DEVELOPMENT REVIEW COMMITTEE (DRC) COMMENT REPORT

PROJECT NAME: 87 Isle of Venice Condos

CASE NUMBER: UDP-S22063

REQUEST: Site Plan Level III Review: Waterway Use and
Modification of Required Yard for 8 Multifamily
Residential Units

(See attached Sheet A2.1) above from Comment 2

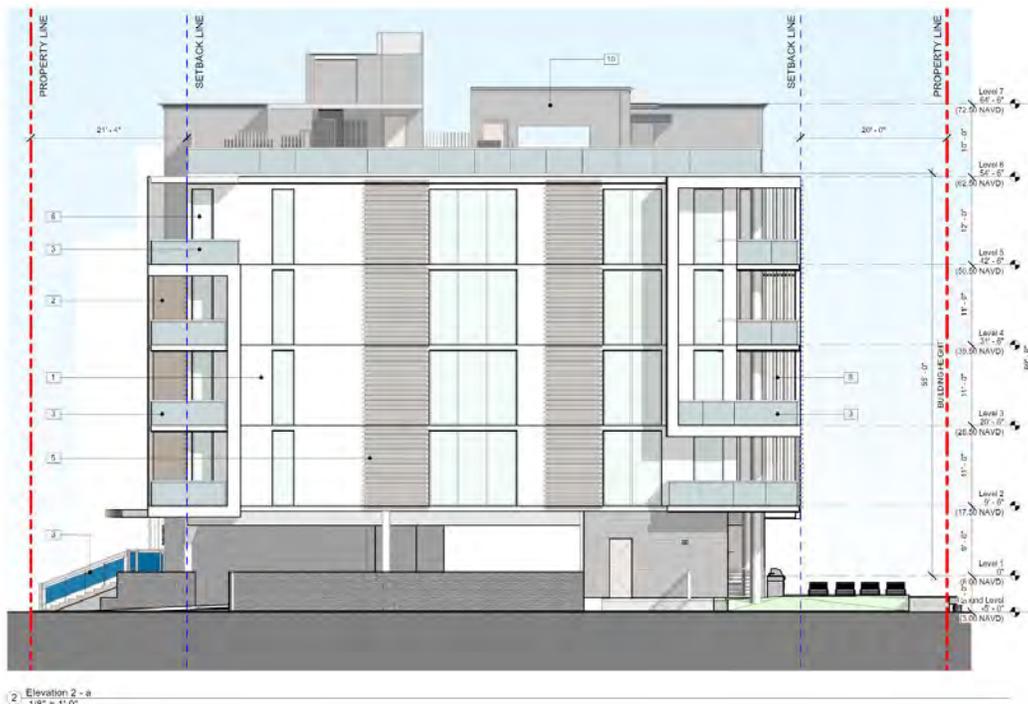
(Sheet A-0.4) A residential multi family unit is not allowed to have a parking garage below the Base Flood Elevation (BFE)

Sheet A-1.1 shows a fire pump room at 4.52, a trash room at 4.52 NAVD, (Electric telecom room at 4.94 NAVD), (show FFE of the rest room at 83 Sq. ft., (show finish floor elevation of Storage rooms) A residential multi family unit is not allowed to have a parking garage below the Base Flood Elevation (BFE)

Elevation Sheet A-2.1 shows ground level of parking garage on elevation sheets at 5' NAVD and shows level 1 at 8' NAVD (see attached Sheet A2.1) See link for the requirements for below grade parking requirements. Reference the link for a mixed use building this building is presently a residential building and is not a mixed used building with the plans submitted. https://www.fema.gov/sites/default/files/documents/fema_technical-bulletin-6_1-2021.pdf

Comment 2 (see attached Sheet A3.1)

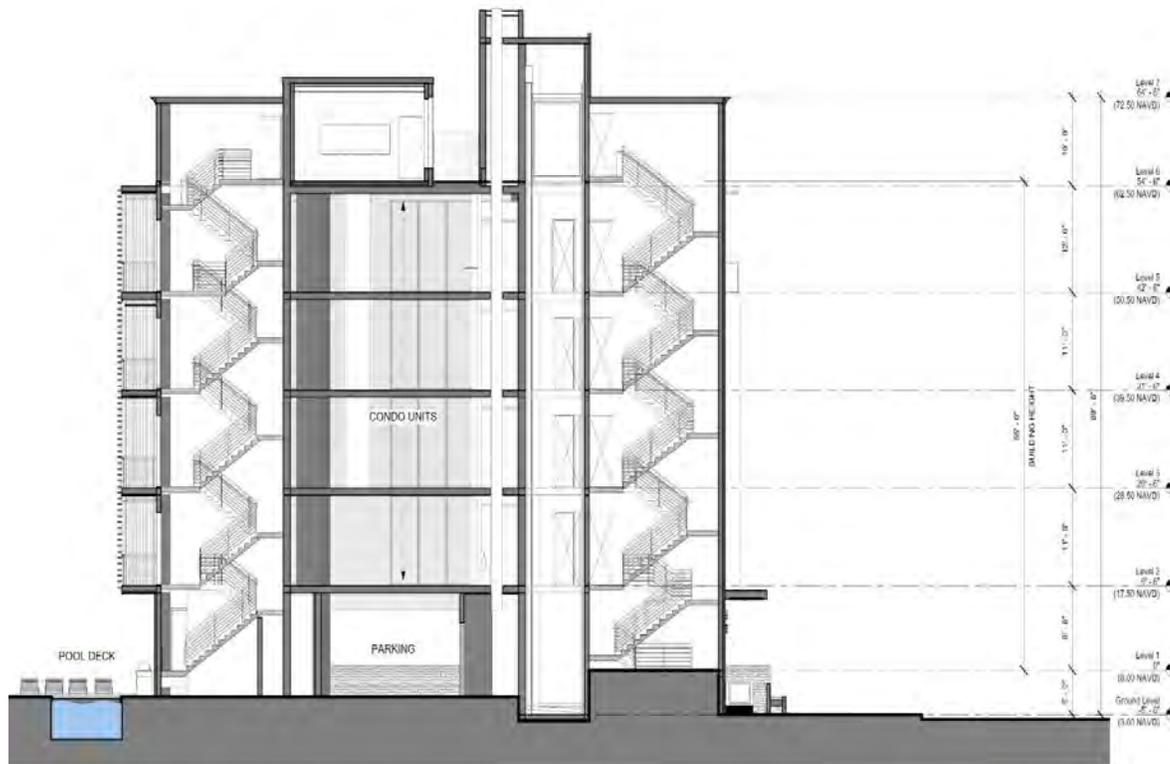
Elevation Sheet A-3.1: shows ground level at 5' NAVD. A residential multi family unit is not allowed to have a parking garage below the Base Flood Elevation (BFE) or rooms or storage below base flood elevation.
